# REPORT

# BOARD OF INQUIRY

CONDUCT AND CHARACTER OF THE  
DRAINAGE WORKS,

NEW ORLEANS, LA.

**EXHIBIT "E."**  
**OLD AND NEW SECTIONS OF SMALL CANALS.**

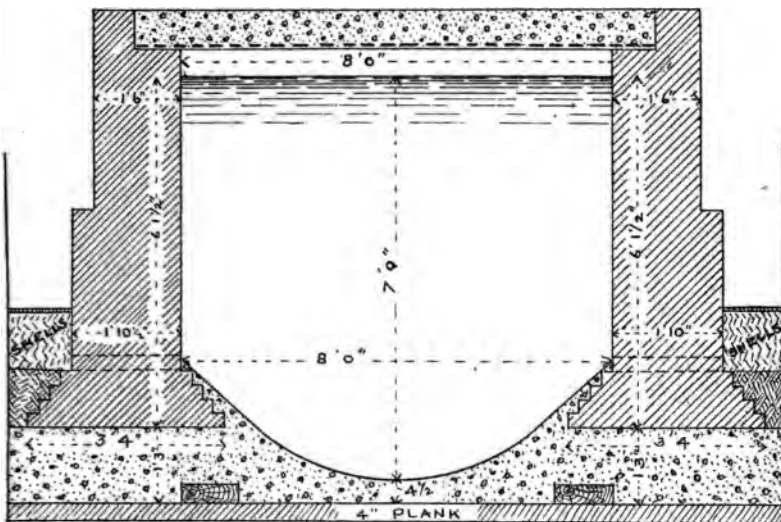
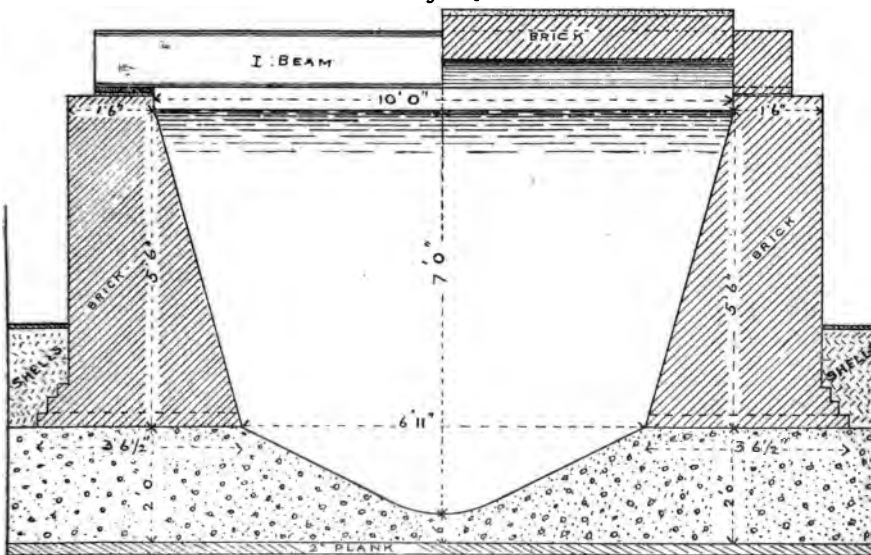
The sectional shape of the drains has been slightly altered from that indicated in the original plans. The side walls are now being made vertical instead of sloping, which alteration reduces the necessary amount of masonry in the walls and also the length of the span of the covering, without reducing the discharging capacity of the drain. The form of support for these walls and of the bottom of the drain has also been changed by providing a continuous timber floor for the whole width of the work. On the score of economy and stability, we fully approve of these modifications.
